Table 14. Hauraki District Council recommendations and actions

Table 15. Waikato Regional Council recommendations and actions

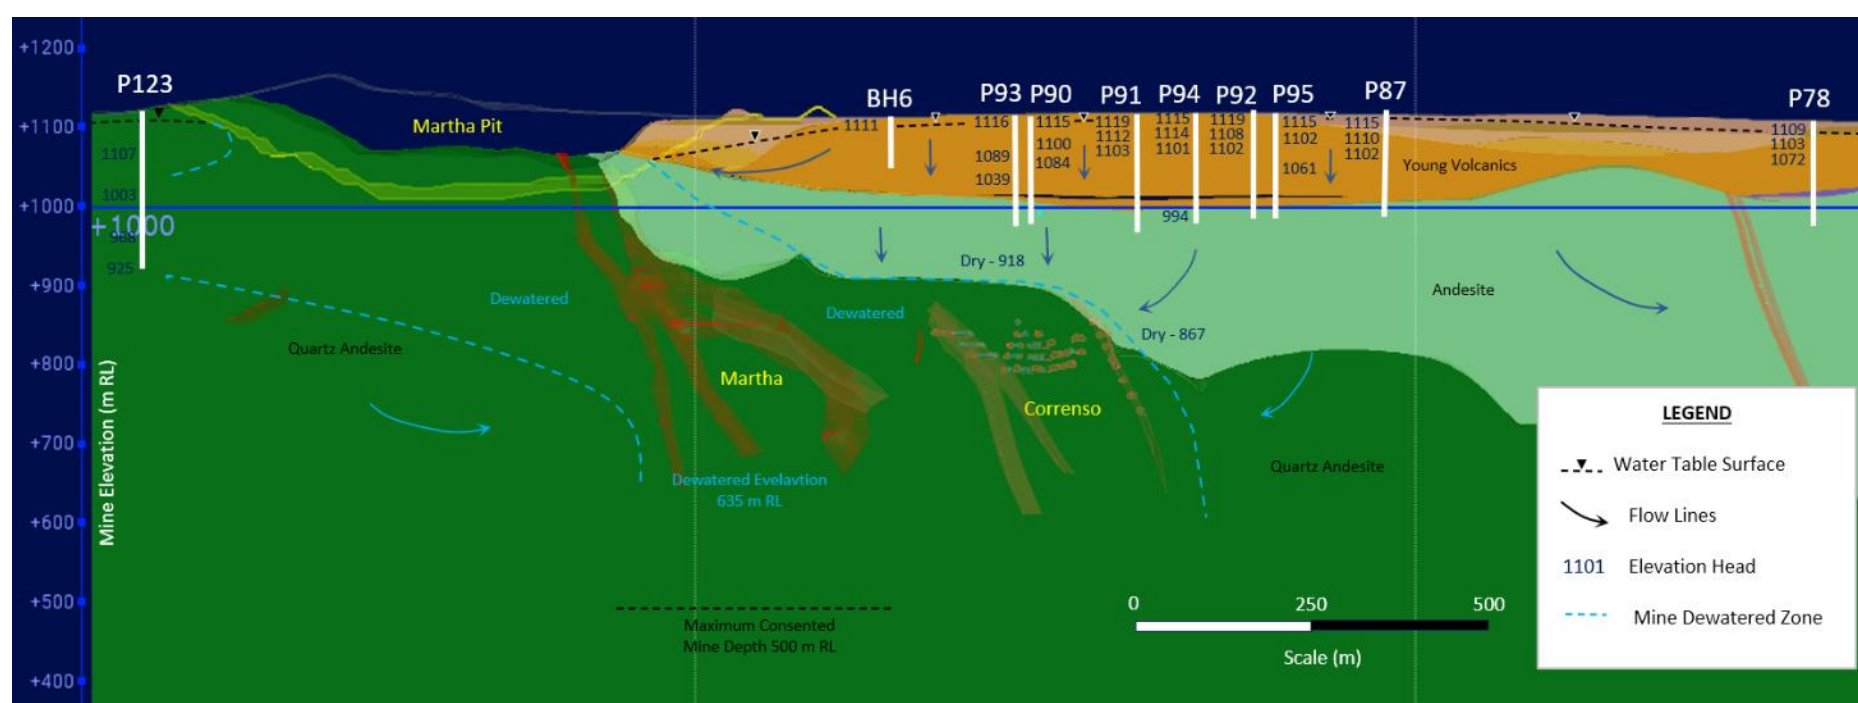
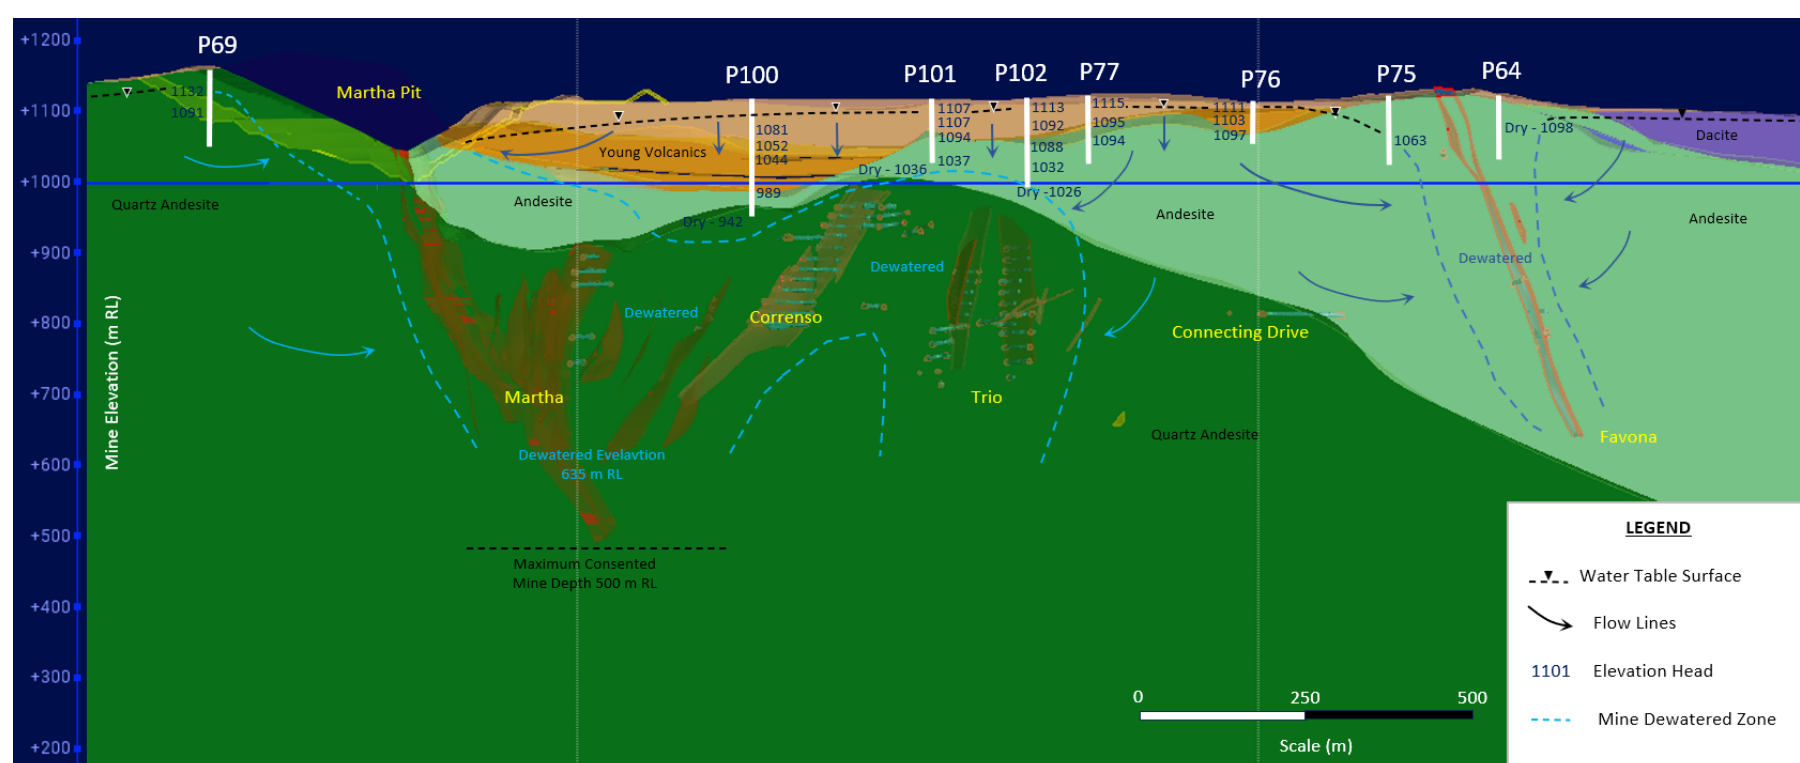
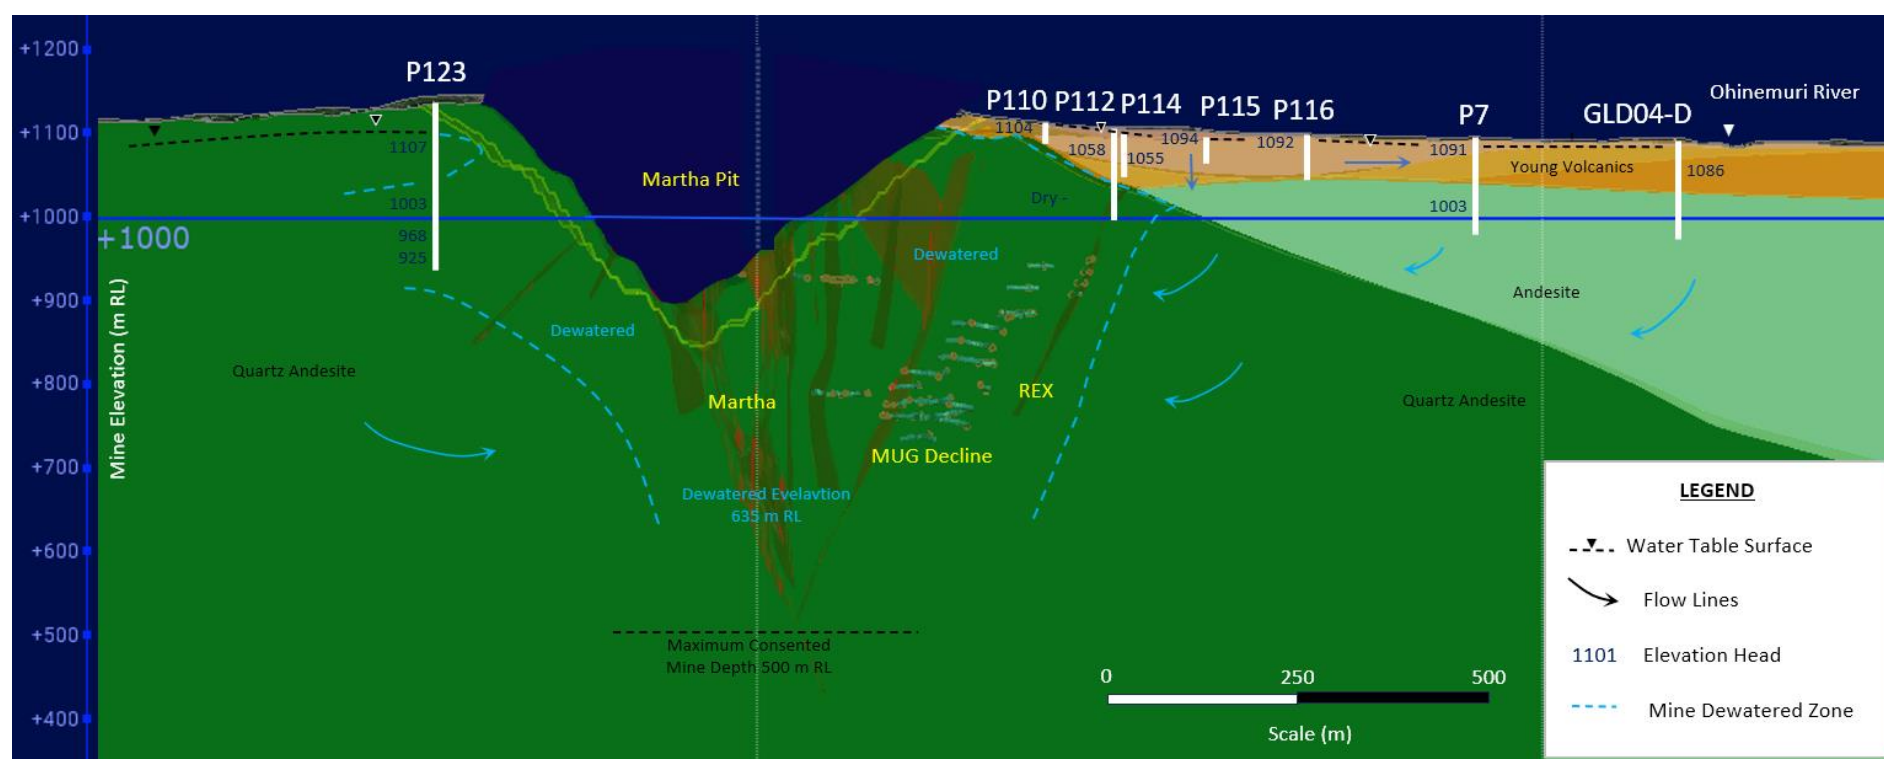
Report Ref	Recommendation	Action
App F	Review the sections presented in Appendix F (Figures 4, 6, 8) and extend them to edge of the basin	The sections have been extended to include only GLD04-D to retain vertical resolution.
App F	Develop a section along strike to show the likely largest extent of groundwater drawdown effects	New section (Figure 10) added to Appendix F.
